In Reply Refer To: HSSD/B-162

In his letter of May 7, 2007, Mr. Dallas James of Armorflex Ltd requested formal Federal Highway Administration (FHWA) acceptance of a new steel strong post (called the Nucor Steel Post) for use in a new 31" (787 mm) high Nucor Strong Post W-beam guardrail system with no blockouts in both roadside and median applications. He also requested formal FHWA acceptance of the Nucor Steel Posts as a substitute for other approved posts in the standard 27" (686 mm) high non-proprietary strong post W-beam guardrail systems with the use of an original plastic blockout. This request was limited to roadside applications only. To support his request, Mr. James also provided a copy of a Holmes Solutions Limited test report dated March 2007, entitled "31 Inch Nucor Strong Post W-Beam Guardrail without Blockouts" and a copy of a Holmes Solutions Limited test report dated March 2007, entitled "27 Inch Nucor Strong Post W-Beam Guardrail with Plastic Blockouts." Mr. James also provided copies of the drawings, test videos, photos, raw data and analysis files and a copy of the correspondence with Mr. Nick Artimovich of my staff concerning the selected test matrix. He also a

General Information
 Test Agency Holmes Solutions, New Zealand
 Test Designation NCHRP 350 Test 3-10
 Test No. 057073101
 Date 5 March 2007

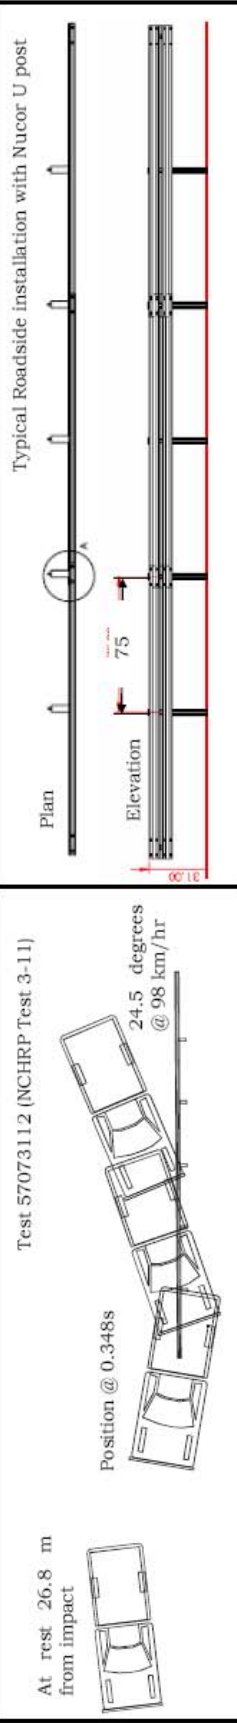
I agree that the selected program is optimal for a full-crash testing of Nucor Strong Posts with the above W-beam guardrail systems. Test 3-10 on the median barrier configuration of the new Nucor Strong Post W-beam guardrail system is considered to produce the greatest risk to the occupant's safety as it is stiffer than the roadside configuration and has a similar potential for snagging. Further, while the proposed updates to the NCHRP 350 recommend the replacement of the 820C with a 1100 kg passenger car (1100C), test 3-10 using a 820C vehicle would produce higher occupant risk than the 1100C vehicle. Also, I agree that the decision to complete Test 3-11 only on the roadside configuration of Nucor Strong Post W-beam guardrail system is justified as this system is structurally less stiff than the median barrier configuration. Using of the 2270P truck (proposed in the updates to NCHRP 350) in this test as opposed to the currently used 2000P truck is in line with the objective to test structural adequacy of the system.

In the conducted tests no detached elements, fragments, or other debris showed potential for penetrating the occupant compartment, nor to present an undue hazard to other traffic. However, in test 3-10 one post was broken off at ground level with a large segment of the post coming to rest 6 m behind the barrier approximately 17 m downstream from the point of impact. Test videos show that the broken off part of the post was sliding at ground level before coming to rest and therefore the hazard to other traffic in median application on a level surrounding surface would be minimal. However, the described tendency of the posts to break off should be recognized and should be taken into account when selecting locations for installations. Also, this tendency may be more pronounced when the system is used in the frozen ground or when the surface is paved.
